Work Order ID 86275

Item Name: Crosstube Turning Detail

DART AEROSPACE LTD	Work Order: 86275
Description: Crosstube Assembly (205/212 Low Aft)	Part Number: D212-664-247
Inspection Dwg: D212-664-247 Rev: B	Page 2 of 2

DRAWING NO. D212-664-247	TITLE CROSSTUBE ASS'Y (205 LOW AFT)	REV. B	DART AEROSPACE LTD ENGINEERING ORDER		D.E.O. NO. D212-664-247-B-1	SHEET NO. SHEET 1 OF 1	SCALE NTS
DRAWN <i>Q</i>	CHECKED <i>ASS</i>	MFG. APPR. <i>AB</i>	APPROVED <i>MD</i>		DE APPR. <i>MD</i>		
DATE 11.07.15	DATE 11.07.20	DATE 11.07.21	DATE 11/07/21		DATE 11.07.21

D212-664-247/-247B
ASSEMBLY DETAIL

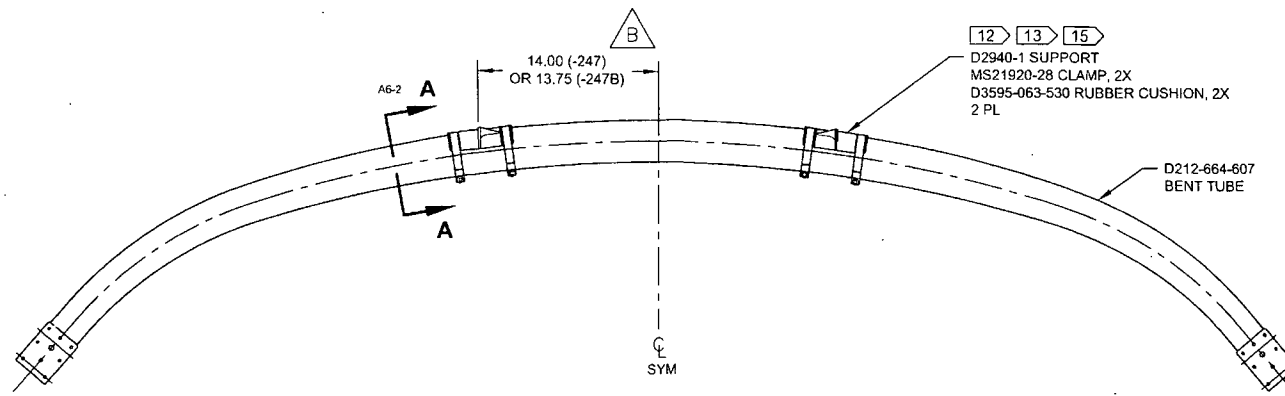
PURPOSE:

REPLACE MAGNOBOND WITH PROSEAL.

NOTE 12 & 15, SHEET 1 IS AMENDED AS FOLLOWS:

- 12) INSTALL D2940-1 SUPPORT USING 0.03" TO 0.06" THICK LAYER OF MAGNOBOND 6398 TO THE SURFACE OF D2940-1 THAT WILL BE IN CONTACT WITH THE CROSSTUBE PER QSI 015. LET CURE FOR 12 HOURS AFTER INSTALLATION AND PRIOR TO PACKAGING.
- 15) TORQUE CLAMPS 80 TO 100 IN-LB. ENSURE AT LEAST 1.5 THREADS SHOWING IN SAFETY AND THAT NUT HAS NOT BOTTOMED-OUT AFTER TORQUING.

- 12) TO INSTALL D2940-1 SUPPORT: ABRABE MATING SURFACE OF SUPPORT AND CROSSTUBE WITH 180-GRIT SANDPAPER AND REMOVE RESIDUE WITH MEK (OR EQUIVALENT). APPLY A 0.04" TO 0.07" THICK LAYER OF PROSEAL 890 CLASS B-2 (OR AMS-S-8802 CLASS B-2) SEALANT TO MATING SURFACE OF SUPPORT.
- 15) TORQUE CLAMPS 80 TO 100 IN-LB. ENSURE AT LEAST 1.5 THREADS SHOWING IN SAFETY AND THAT NUT HAS NOT BOTTOMED-OUT AFTER TORQUING. **PRIOR TO PACKAGING, RE-CHECK TORQUE ON CLAMPS AFTER PROSEAL 890 SEALANT HAS CURED FOR 72 HOURS.**
